CERTIFICATE OF APPROPRIATENESS

Applicant: Karen Brazier, Design3 Studio, for Troy and Terri Hamm, owners

Property: 1106 Columbia St, Tracts 14 and 15A, Block 196, Houston Heights Subdivision. The property includes a historic 1,000 square foot, one-story wood frame single-family residence and a detached garage situated on a 7,260 square foot (55' x 132') interior lot.

Proposal: Alteration – Addition *Revision*

NORTH SIDE ELEVATION

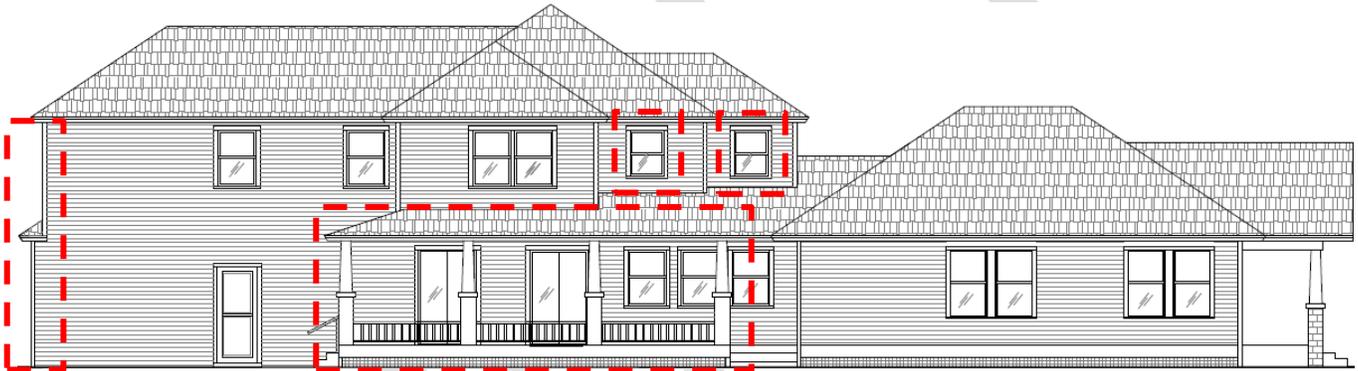
- Increase the depth of the addition from 62' to 64'. The first level of the addition will be 1' deeper than the second level.
- Increase the width of the porch on the north elevation of the addition from 20' to 38'.
- Reduce the size of two windows on the north elevation of the second level of the addition. For further detail, see North Side Elevation on p. 6 and Window Detail – North Elevation Second Level on p. 12.
- Alter the fenestration pattern on the second level of the south elevation of the addition. The specifications of the windows remain the same. For further detail, see South Side Elevation on p. 7 and Window Detail – South Elevation Second Level on p. 12.

Side Elevation: Approved 7/28/2016: The addition will feature a variety of 1/1 double-hung and fixed wood windows, as well as two sets of single-lite French doors leading out onto a covered wood porch. The side porch will measure approximately 20' wide by 15' deep.

Proposed: The side porch will measure approximately 38' wide by 15' deep. Two windows on the second level of the addition will be reduced from 3'-0" x 5'-0" and 3'-2" x 4'-8" to 3'-0" x 4'-0".

SOUTH SIDE ELEVATION

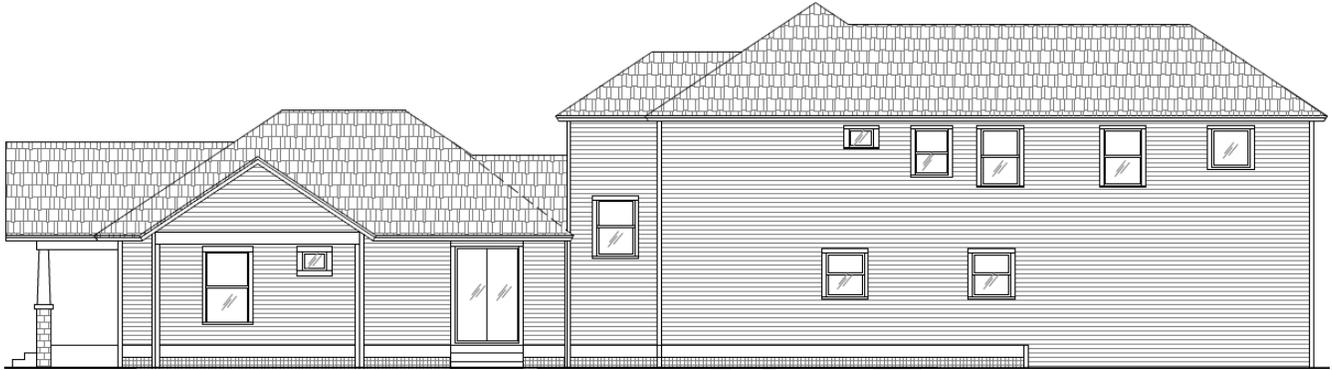
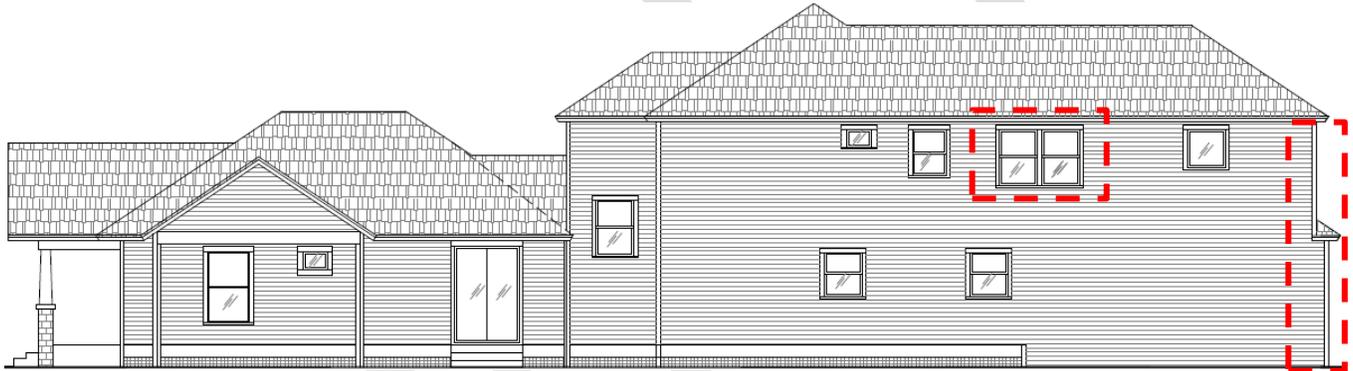
Side Elevation: Approved 7/28/2016: The addition will feature a variety of 1/1 double-hung and fixed wood windows.

Proposed: Two 3'-2" x 4'-8" double-hung wood windows on the second level of the addition will be moved closer together to form a set.

EAST (REAR) ELEVATION

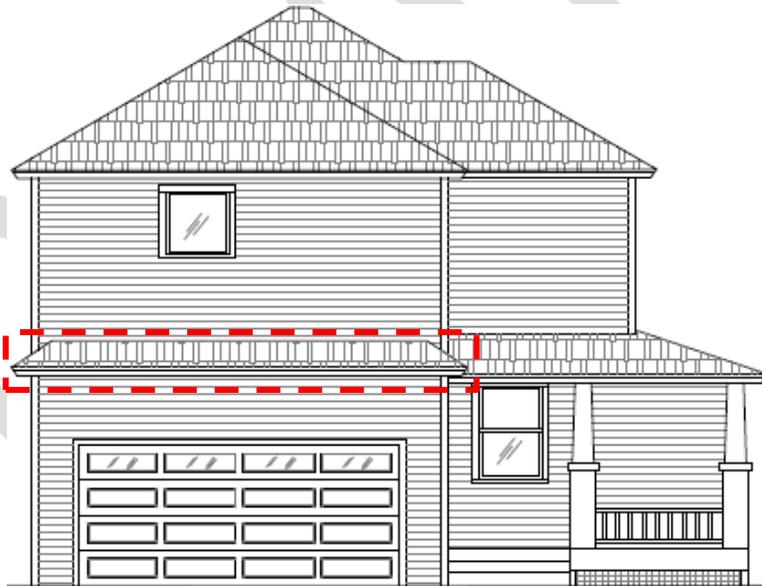
Shape/Mass: Approved 7/28/2016: The two-story addition will have an overall width of 30' and a depth of 62'. The addition will have a 21' eave height and a 29' ridge height. The addition will be inset 8' at the northeast corner and 8" at the southeast corner of the original residence. The south elevation of the addition will then extend back 7' from the existing rear wall, and then extend out to the 3' setback.

Proposed: The overall depth of the addition will increase from 62' to 64'.

FIRST FLOOR PLAN

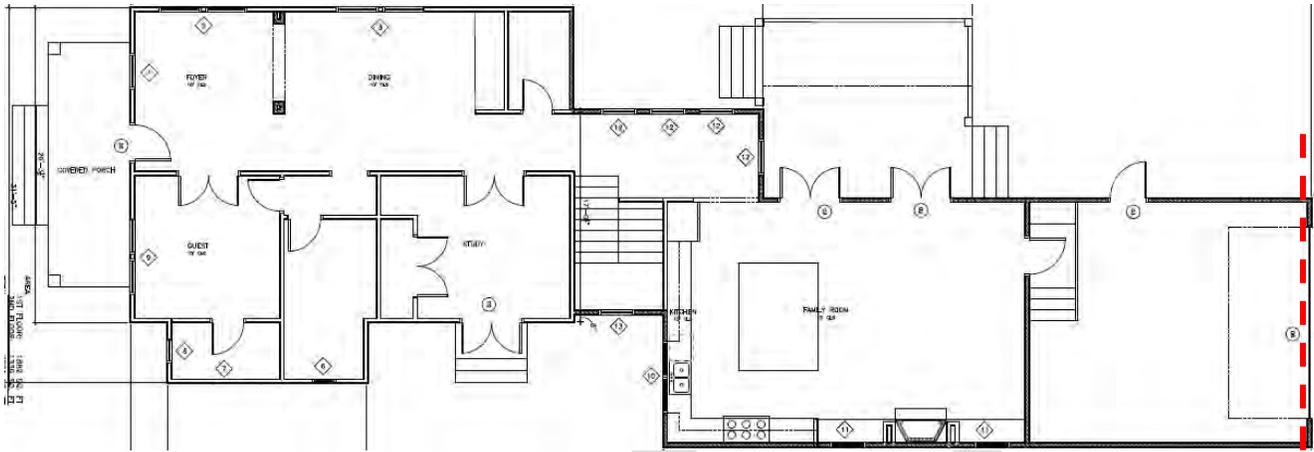
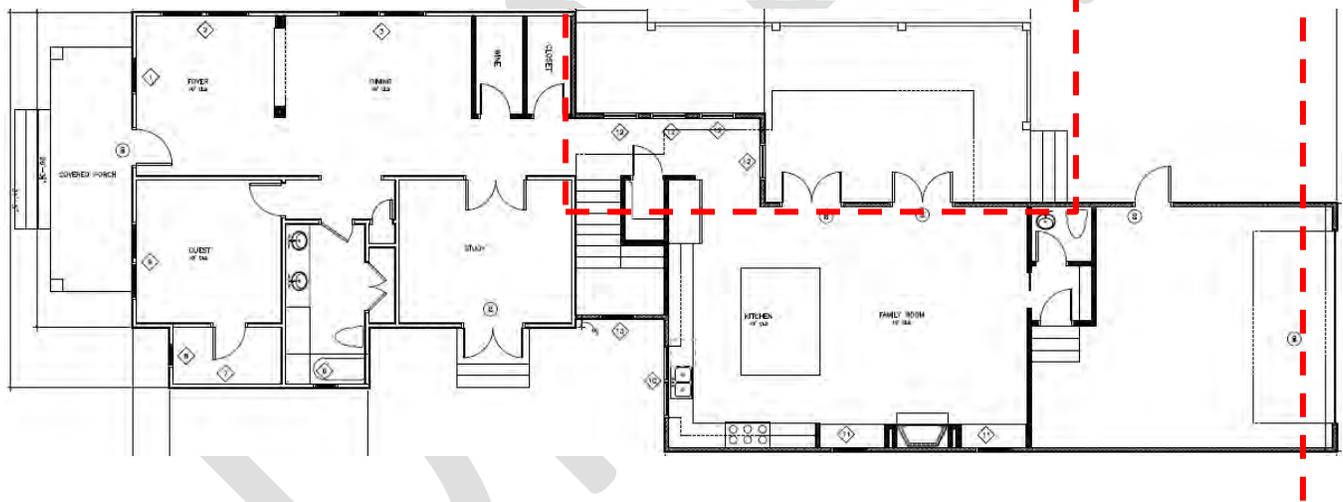
Proposed: The addition will be setback 11' from the rear property line.
